Memorandum to the City of Markham Committee of Adjustment October 4, 2019

File:	A/82/19
Address:	6 Tollesbury Place Markham
Applicant:	TAES Architects Inc. (Shenshu Zhang)
Hearing Date:	Wednesday, October 16, 2019

Memorandum to the City of Markham Committee of Adjustment August 30, 2019

Re: A/82/19 (Minor Variance Application) 6 Tollesbury Place, City of Markham Owner: Yuan Tian

Project rumber		12019008 6" = 1%0"
Drawn	Scale	
Checked	Date	AUGUST 2019
Statistics		
Drawing No.	002

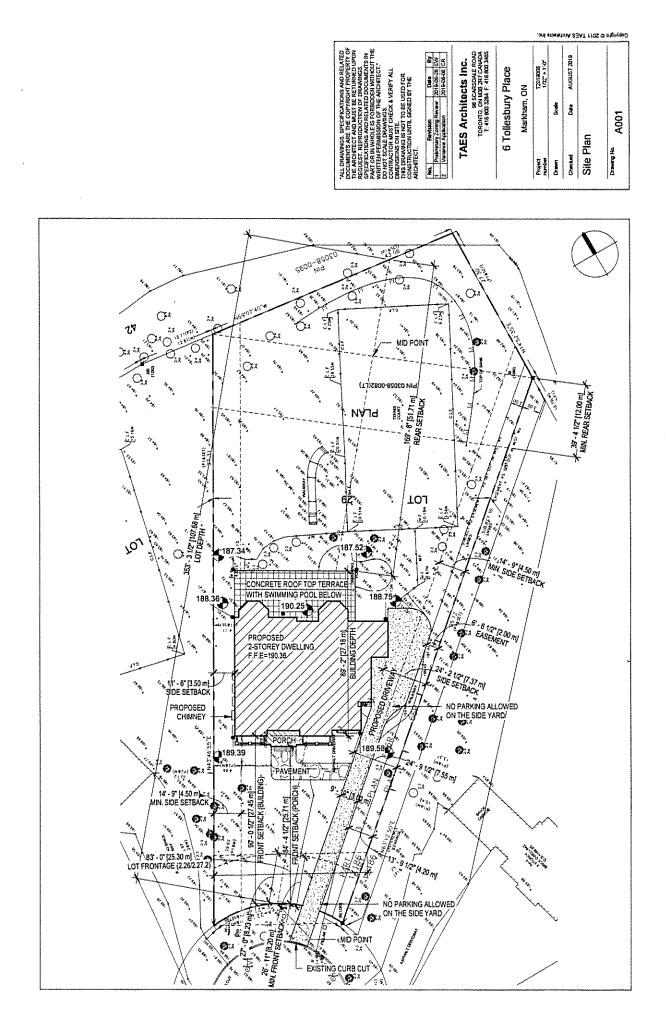
The By-law requires a minimum side yard setback to the driveway of 4.5 m (14.76 ft) for the portion in the front yard, whereas the applicant is proposing a side yard setback to the driveway of 4.2 m (13.78 ft). This is a reduction of 0.3 m (0.98 ft). The portion of the driveway, in the interior side yard does not have a setback requirement in the By-law. However, the proposed 2.0 m (6.56 ft) setback within the interior side yard allows for storm sewer and overland flow drainage through an easement in favour of the City. As a condition of approval, the portion of the driveway within the interior side yard should maintain a minimum 2.0 metre interior side yard setback, and that the Owner provide screening for this portion of the driveway and soft landscaping along the remainder of the driveway (see Appendix "A"). Staff believe the variance to be minor in nature and appropriate for the development.

The applicant is requesting a minimum west side yard setback of 11.48 ft (3.5 m), whereas the By-law requires a minimum side yard setback of 14.76 ft (4.5 m). This represents a difference of 3.28 ft (1.0 m). Staff's comments for the September 11, 2019 meeting dated August 30, 2019 remain applicable.

- That the portion of the driveway within the interior side yard maintain a minimum 2.0 metre interior side yard setback to the satisfaction of the Director of Engineering or their Designate;

- That a Landscape Plan be provided showing adequate screening and soft landscaping between the driveway and property line, and that the Secretary-Treasurer receive written confirmation that this condition has been fulfilled to the satisfaction of the Director of Planning and Urban Design or designate;
